Technical Review of Revenue Proposal

**Review of Proposed Replacement
Capex in TransGrid Revenue
Proposal 2014 - 2019**

Australian Energy Regulator

October 2014

Figure 4: Risk assessment for substation renewal projects before and after treatment. (Risk Categories: Red = Extreme; Orange = High; Yellow = Medium; Green = Low)

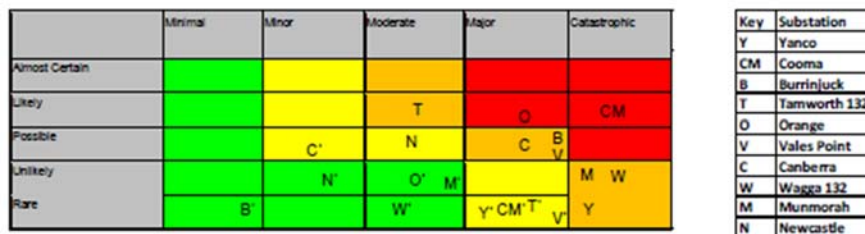
- 50. We requested a copy of a similar representation of project risks for other asset classes. However, it became evident that this information was prepared in response to our request only. We believe this further reinforces our view that such representations of risk at an asset class level are not currently used within TransGrid to understand current and forecast risk levels.
- 51. During our onsite meeting we requested a copy of any corporate reporting for ‘Extreme’ risks for substations (such as Cooma) as identified in Figure 4 and as required by TransGrid’s reporting process. We were provided with a copy of a Board level risk report

53. Figure 5 shows that the highest assessed risk for all risk categories (shown by an 'x') is Medium (yellow). Yet, when aggregated to the single risk rating as shown in Figure 4, we found that the risk was elevated from Medium to High. We selected a further example to determine if this was an isolated case. The Needs Statement risk assessment for the Orange substation renewal project was similarly found to have increased from High to Extreme when aggregated.
